SUBJECT: Minor Modification

Interim Planned Development-Transit (IPD-T) and Major Special District (SD) Permit No. 2017/SDD-11

Hawaii Ocean Plaza

1370 Kapiolani Boulevard - Kapiolani Tax Map Keys 2-3-016: 018 through 020

EXHIBIT B-13 RESIDENTIAL CONDOMINIUM - ROOF PLAN

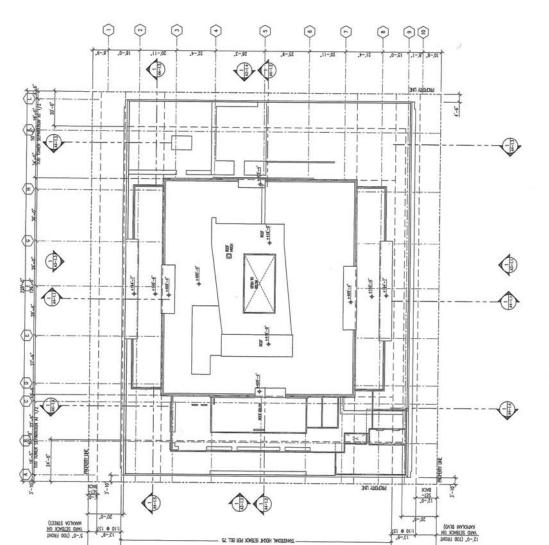
Transitional Height Setback Encroachment: The Applicant proposes to encroach two feet into the transitional height setback along Kapiolani Boulevard and Makaloa Street (see Exhibit B-15, B-17 and B-20). The architectural embellishments were not shown on the conceptual plans. For a complete and consistent facade design, the building fenestration is included on all four sides of the building and resulted in the slight encroachment. The encroachment at the roof of the tower represents a very small percentage of the total building volume. The encroachment is minimal and will not negatively impact the surrounding properties.
